MONITORING YEAR 5 ANNUAL REPORT

HENRY FORK MITIGATION SITE

RE: **Response to MY5 Draft Report Comments**
Henry Fork Mitigation Project
DMS Project # 96306
Contract Number 005782
RFP Number 16-005298
Catawba River Basin – CU# 03050103 Expanded Service Area
Catawba County, North Carolina

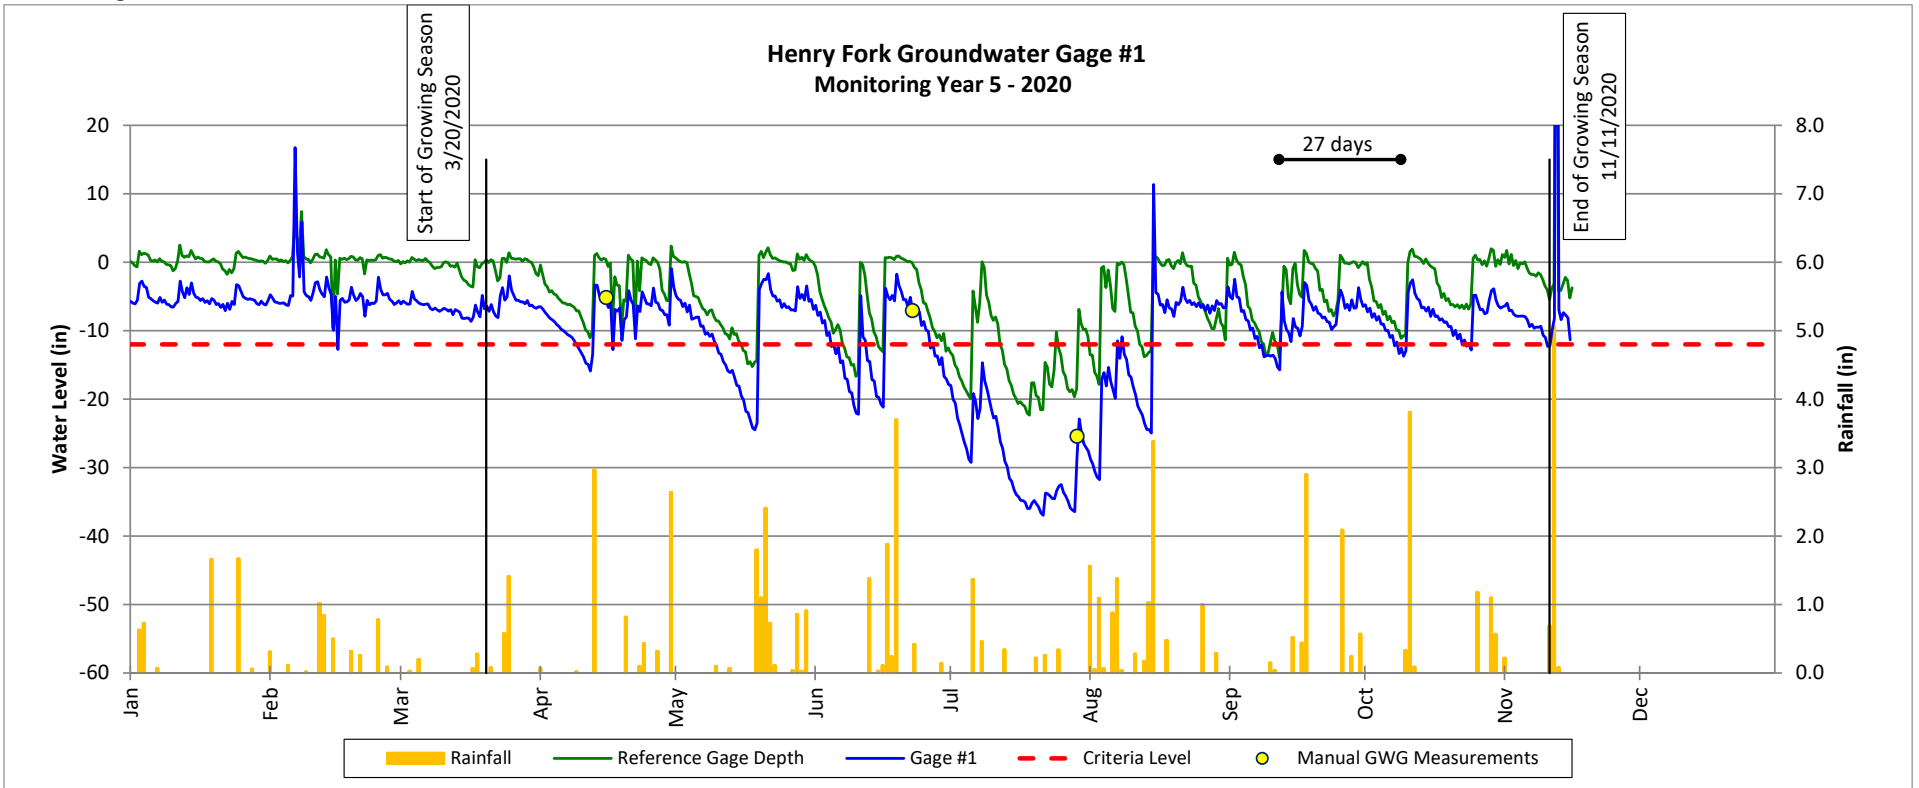
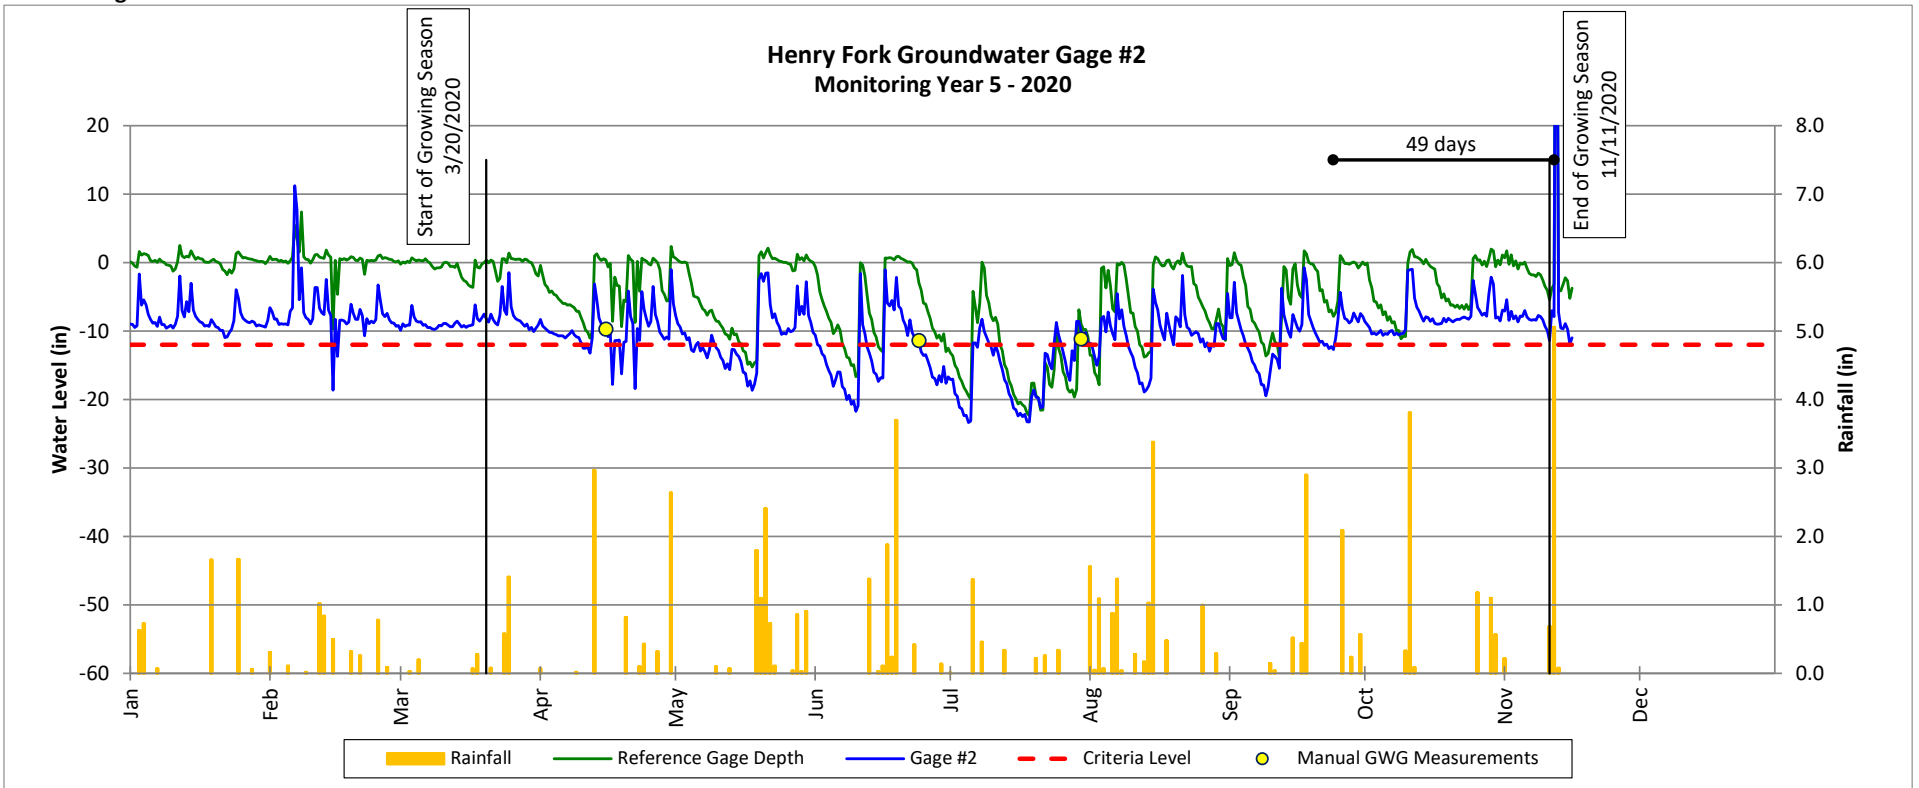
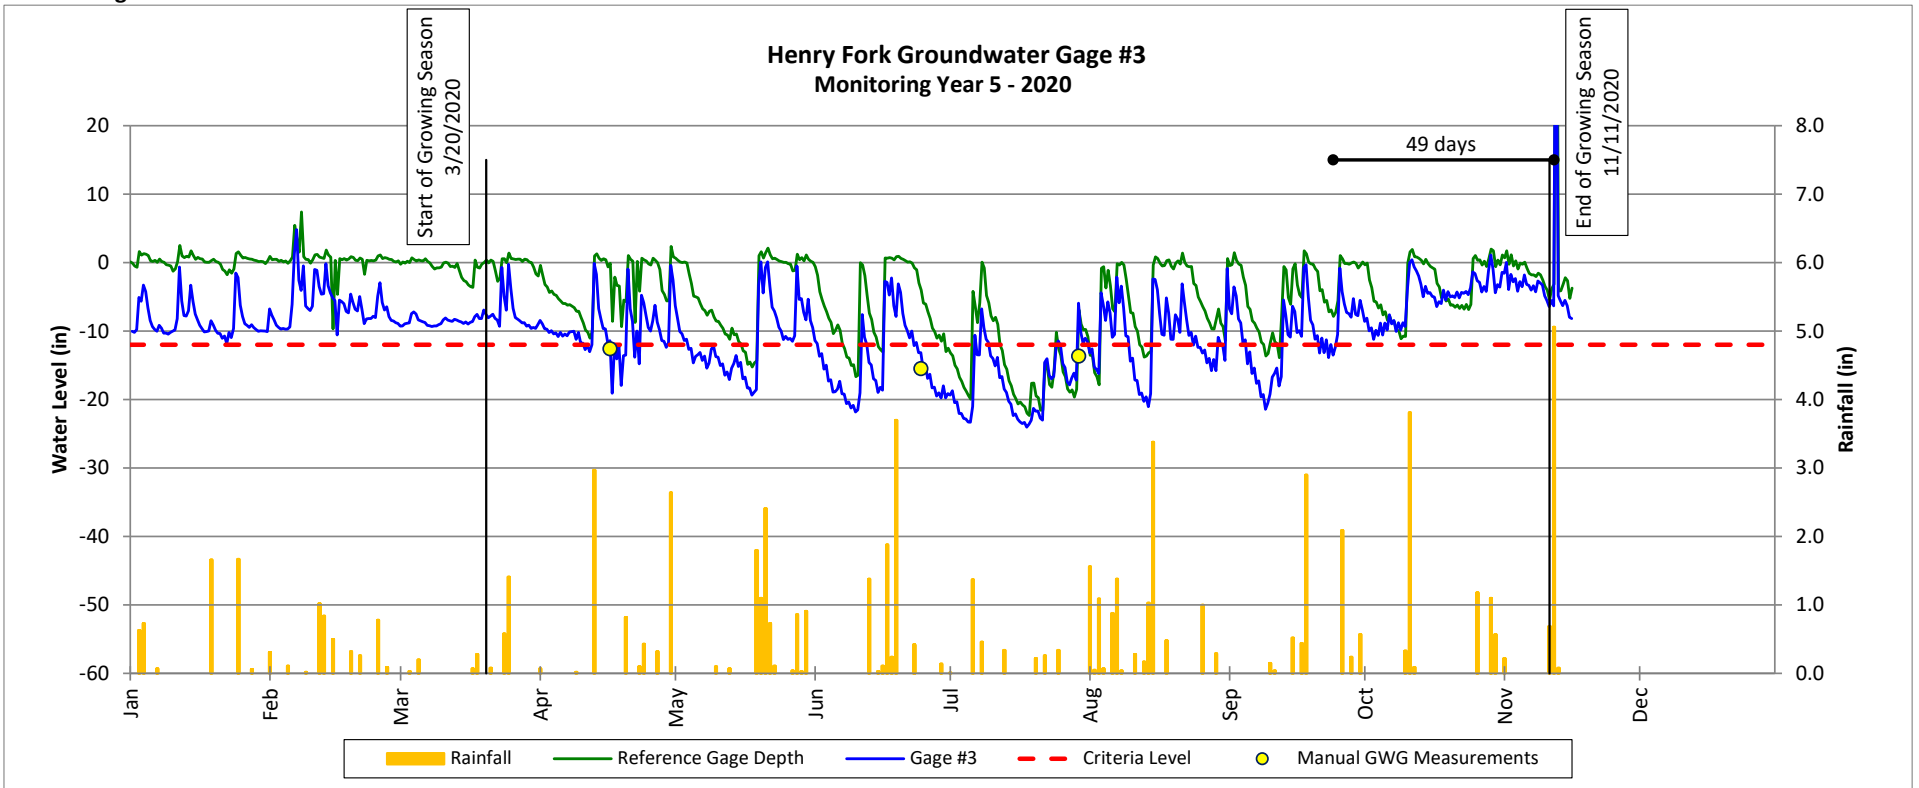
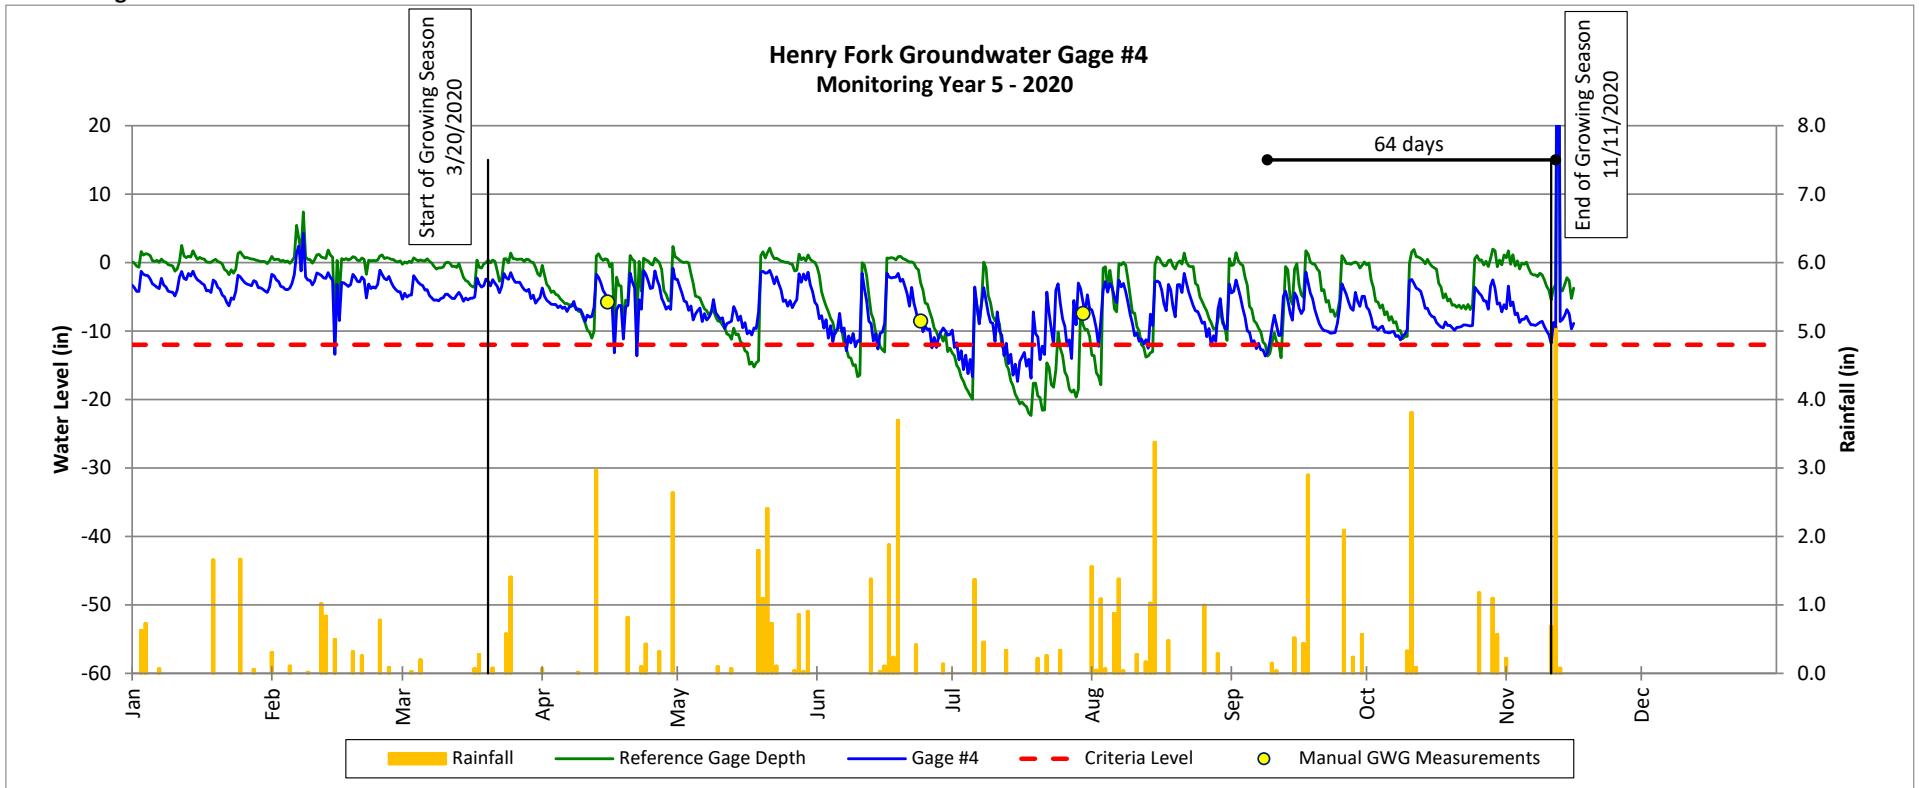
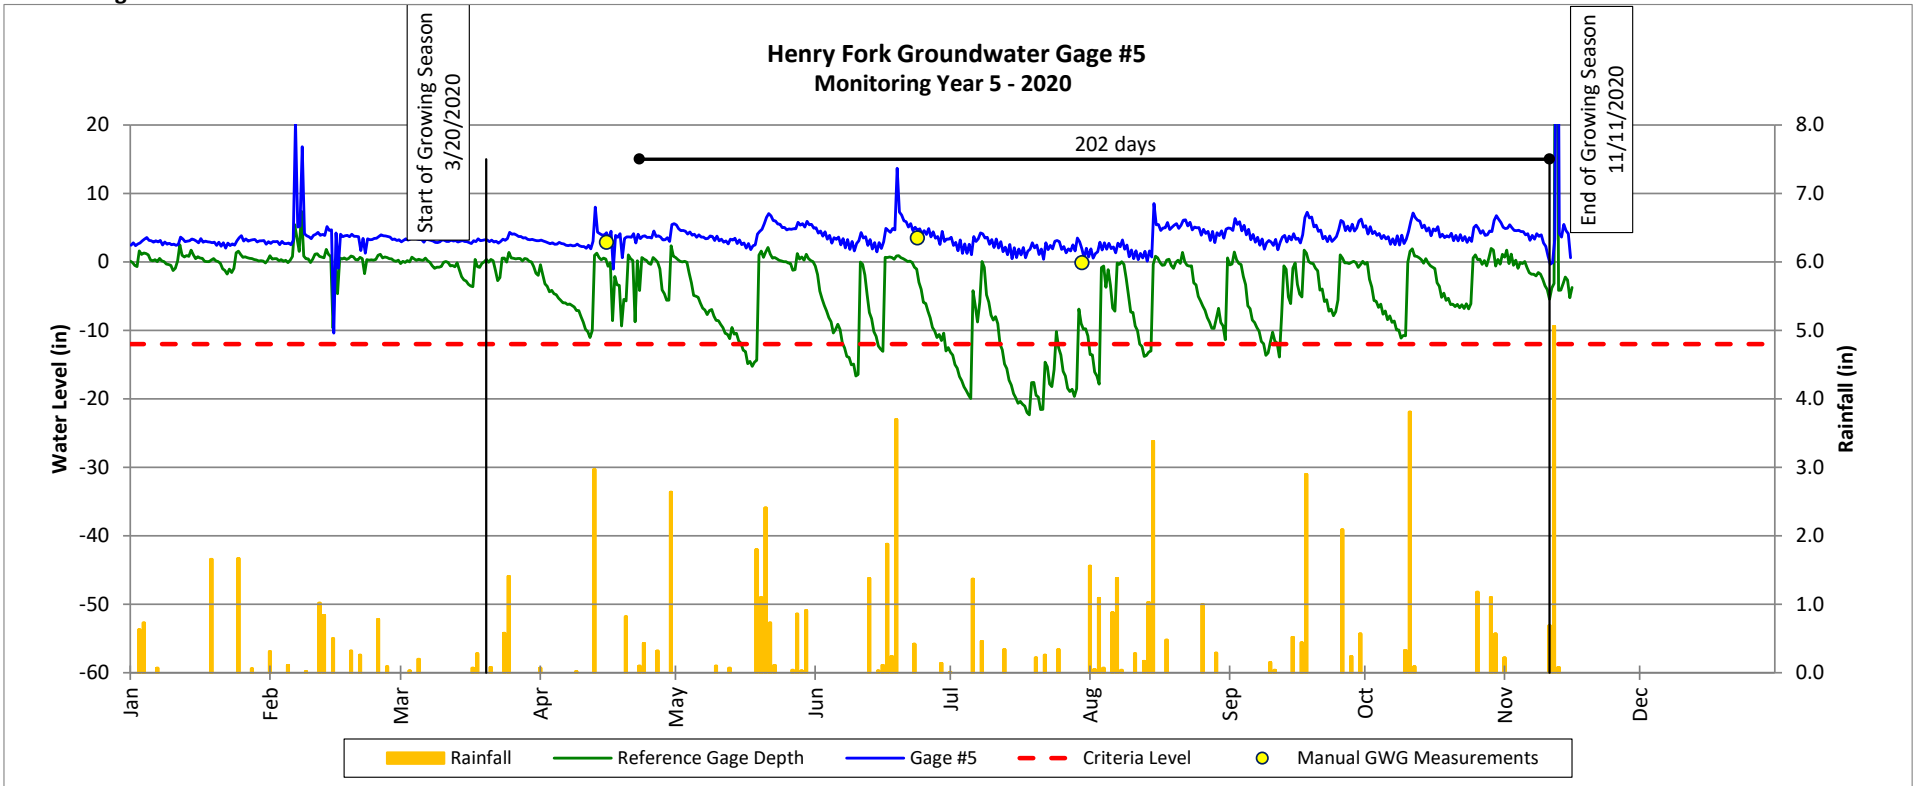
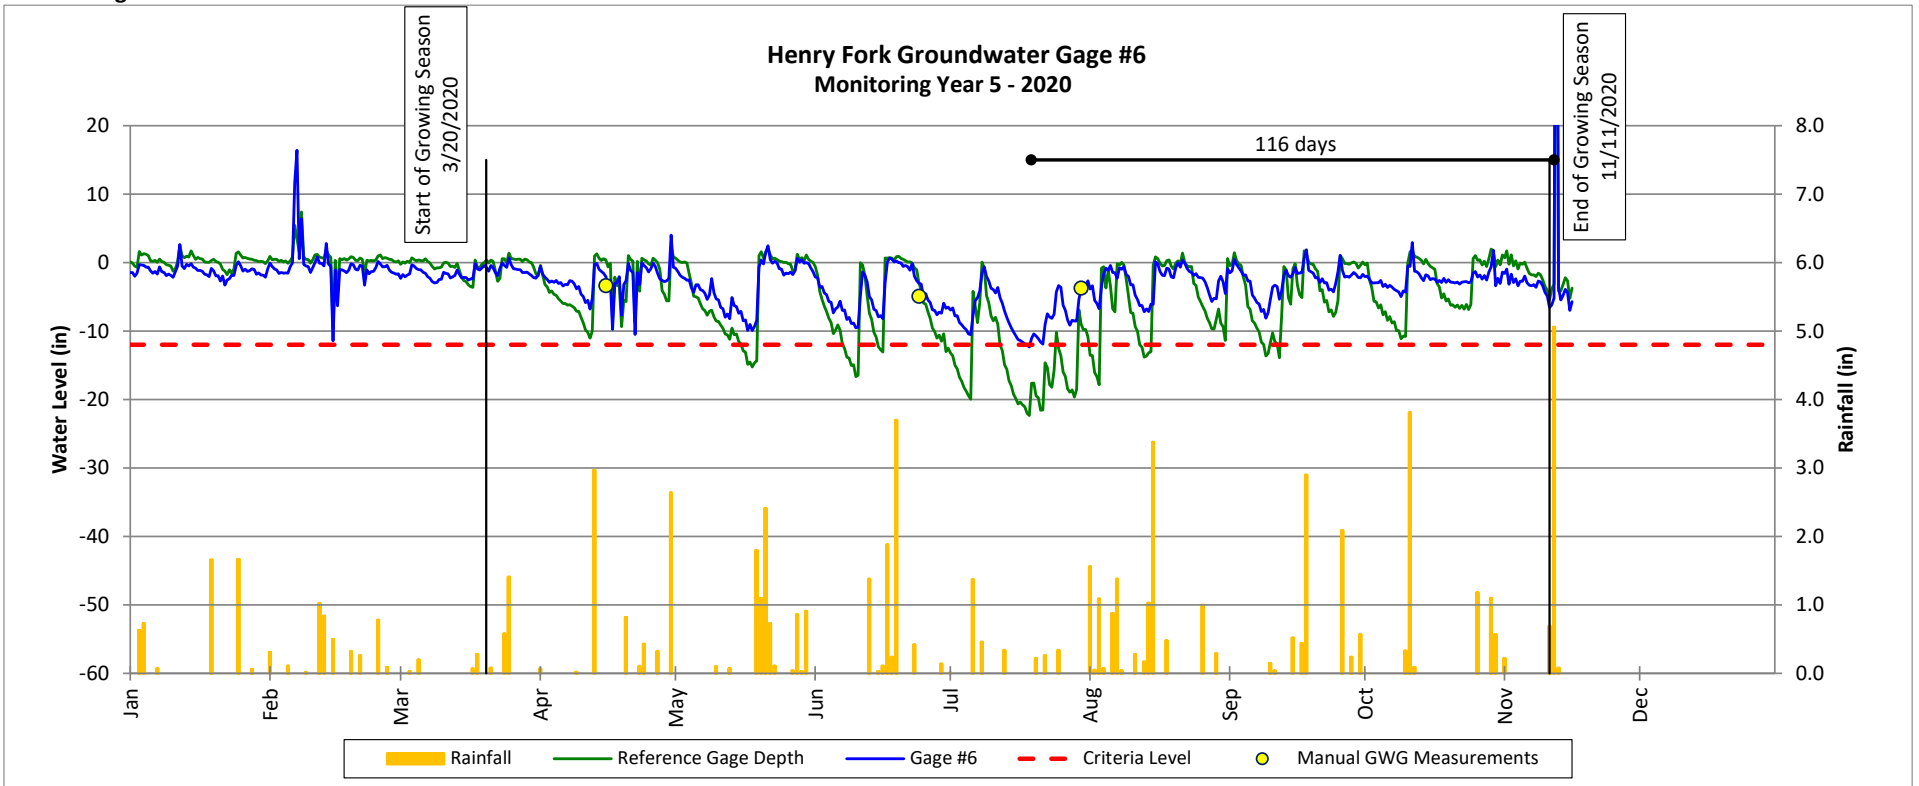
DMS comment: Groundwater Gage Plots: The note at the bottom of the graphs regarding the barotroll malfunction is unclear. It says the data collected during the February and April 16-17 malfunctions were omitted, but then then says the readings conducted during April 16-22 was verified and included. Is the April 16 date in the verified statement supposed to be April 21? Please review and revise as necessary.

Wildlands response: The note at the bottom of the groundwater gage plots has been revised and simplified to indicate that the data collected during the February and April malfunctions was omitted from the reported data.
